3321 N Street NW WDC 20007
Chimney repair and in-kind flat roof replacement.

Response

Area of roof
work

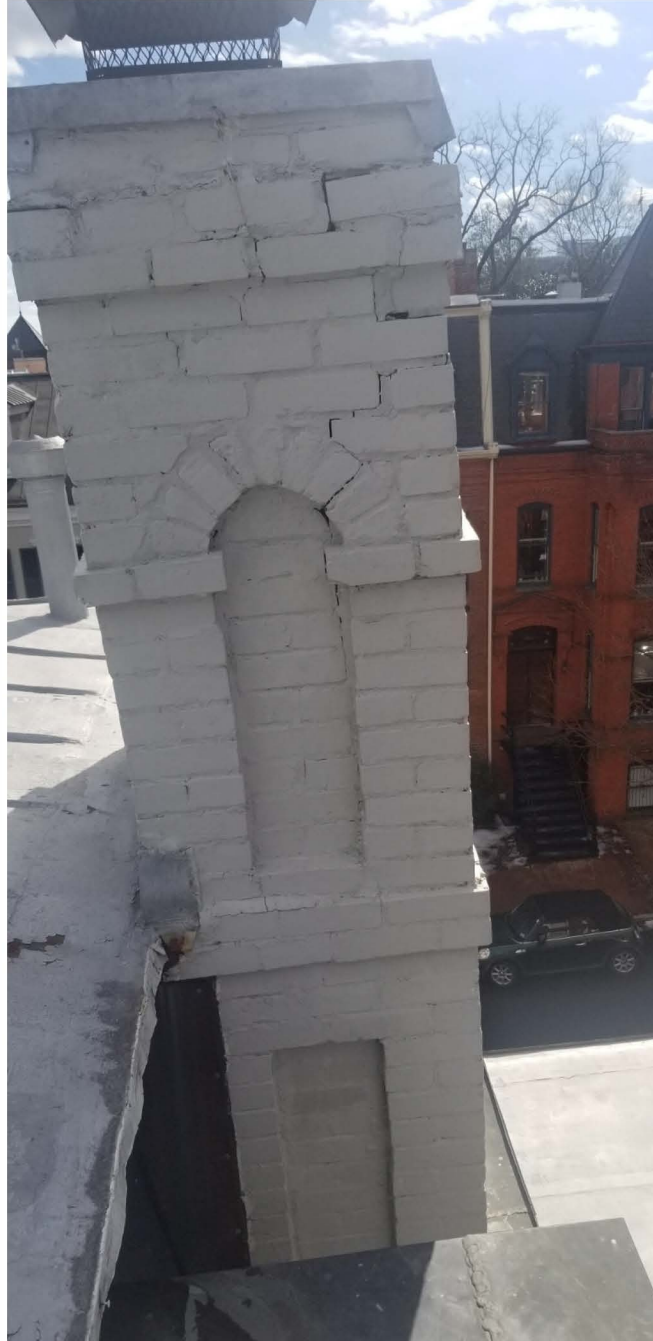
2. Detailed and labeled photos of the entire property.
 - a. **Photos are labeled for location and areas of work have been outlined.**
3. Please specify exactly which part of the roof would be replaced.

- a. **Only the flat roof area in the rear will be replace.**
4. Please include information about the existing roof material and the proposed roof material.

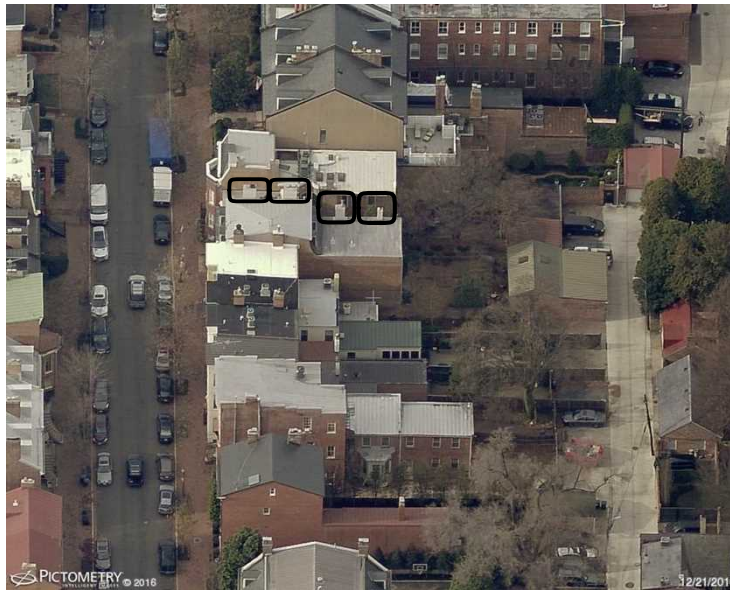
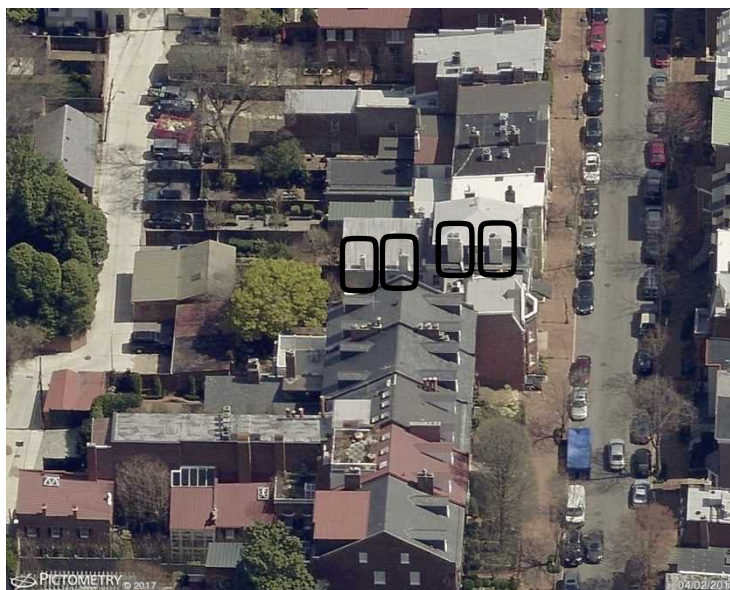
- a. **No gutters or downspouts are included in this scope of work.**
7. Please include detailed information about plans for chimney repair. Repointing? Rebuilding? Please clarify.

- a. **The damaged and cracked chimney areas shown in the photo will be replaced in kind, repointed and painted identically to what is existing.**
